## Huber Transmission Service/Warranty Replacement

### Models Affected

HP850 SCi S/N Prior to 0M953493  
HP1075 SCi S/N Prior to 0M950625  
Huber Transmissions have P/N 842978A05  
B.A.M. Transmissions have P/N 841918A05

### Situation

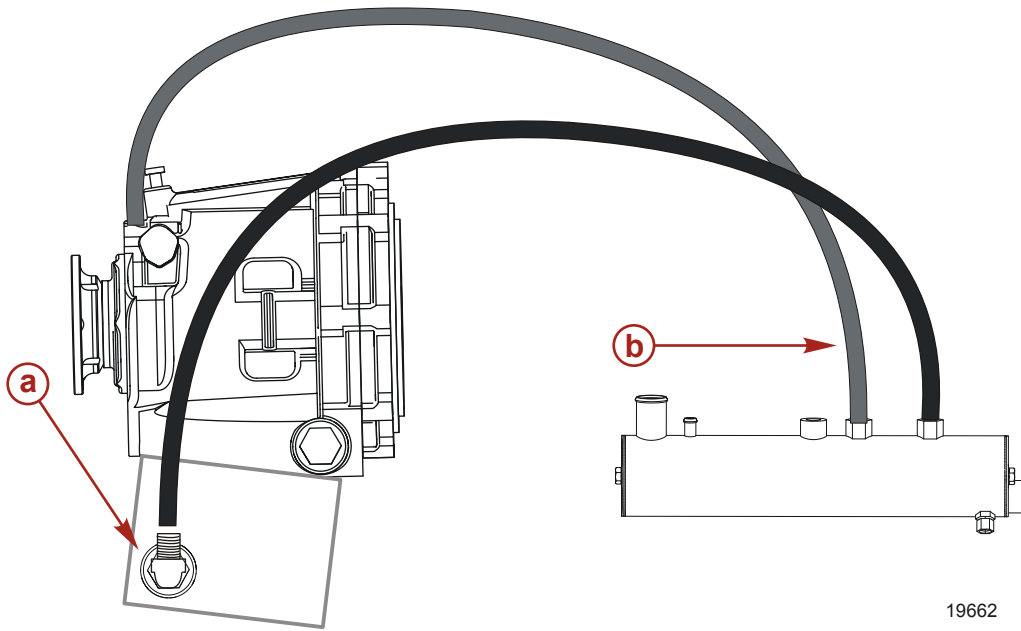
The Huber transmission used on the HP850 and HP1075 SCi will be replaced with the B.A.M. transmission for service or warranty repairs. In addition to the transmission replacement, two oil lines and two hydraulic fittings (not supplied) will have to be replaced.

Part Number	Description
32-47516 9 Hose assy, (37.0 in.)	Replaces the transmission cooler hose that is routed to the sump of the transmission
32-821284A36 Hose assy, (17.5 in.)	Replaces the oil cooler hose that is routed underneath the transmission
22-847731 12 Fitting, (45 Degree)	Replaces the lower straight fitting on the Starboard oil cooler T-fitting
22-847732 12 Fitting, (120 Degree)	Replaces the lower 90 Degree fitting on the Port oil cooler
